## NHTSA SAFETY RECALL

### SUPPLEMENTARY INFORMATION TO IGNITION MODULE RELOCATION Recall #06V-301

Measurements A and B.

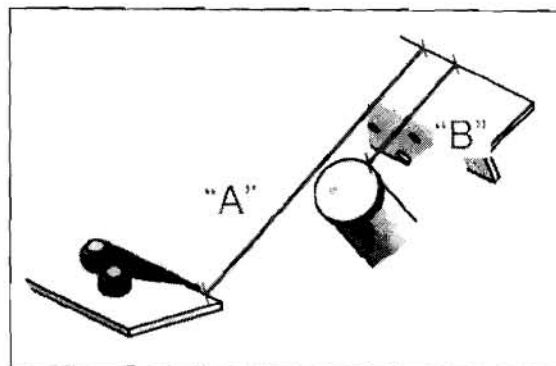
1. On 2005 models, if the ignition module relocation kit is **not installed**, measure the distance between the front and rear crossmembers (**measurement A**). If this measurement is less than 8-7/8", or if the measurement between the rear crossmember and the back of the oil filler cap is greater than 4.0" (**measurement B**), the motorcycle will require the supplemental kit, P/N 203-000019-00. If this is the case, call Big Dog Motorcycles Customer Service at 316-267-9121. Supply the project number of the motorcycle to obtain the supplemental kit P/N 203-000019-00.
